FRANKLIN COUNTY FISCAL COURT – SIMON HOUSE RENOVATION

ADDENDUM NUMBER TWO

7 APR 21

M-2.01A

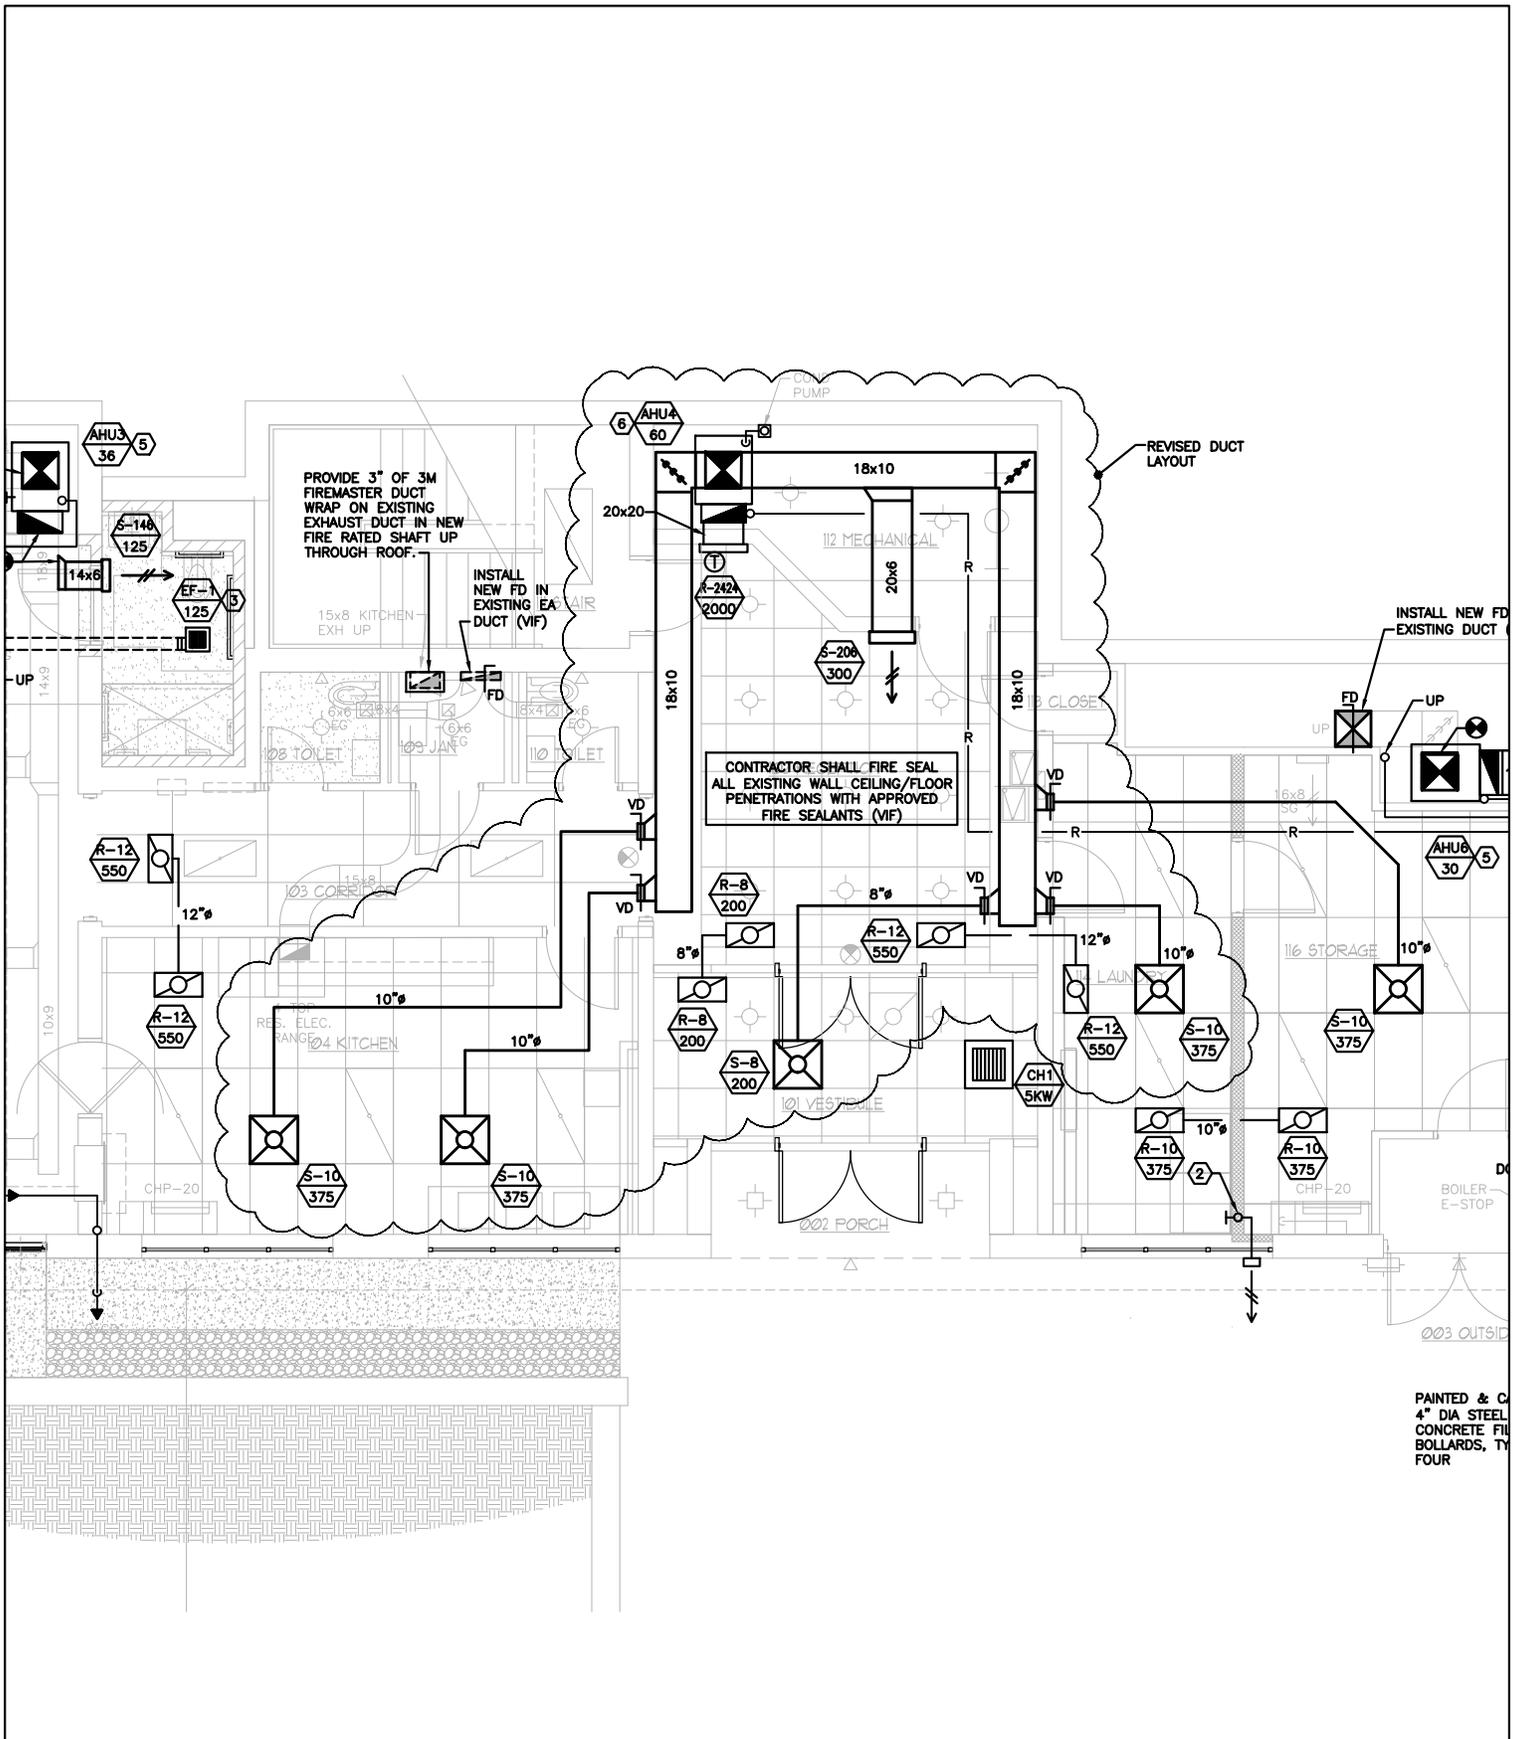
- In Reception 102, Vestibule 101, Kitchen 104 and Laundry 114, the Contractor shall remove or relocate all hydronic water piping, domestic water lines, brackets, hangers, valves, etc. and as required for installation of new ductwork in these rooms, VIF. Refer to revised Mechanical Plan on Sheet M-2.01A.

- See attached plan for revised ductwork in Mechanical 112, Reception 102, Vestibule 101, Kitchen 104, Laundry 114, and Storage 116. See attached drawing M-2.01A.

- In Reception 102, Vestibule 101, Kitchen 104 and Laundry 114, the Contractor shall remove or relocate all light fixtures, cables, wiring, conduits, brackets, hangers, etc. and as required for installation of new ductwork in these rooms, VIF. Refer to revised Mechanical Plan on Sheet M-2.01A
